# ***Current status of EC –JPN bilateral meeting on OBD-gtr draft***

27<sup>th</sup>/Aug 2015

#### Requirements

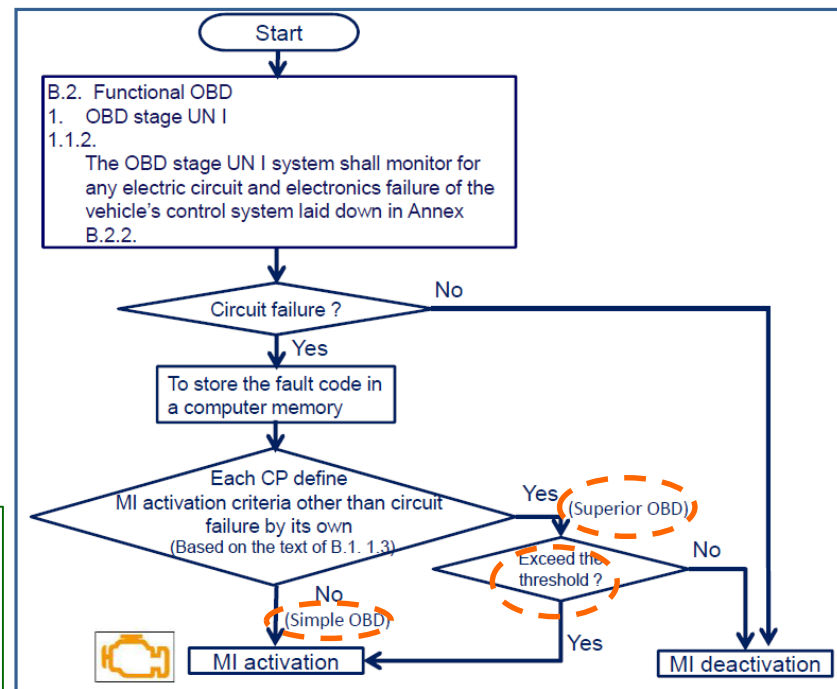
**( )**: wording to be studied

Corrected wording in the flowchart:

“Simple OBD”→“Stage UN-I”

“Superior OBD”→“Enhanced OBD”

“Exceed the threshold”→“fail the threshold” (needs native check)

**Agreed !!**
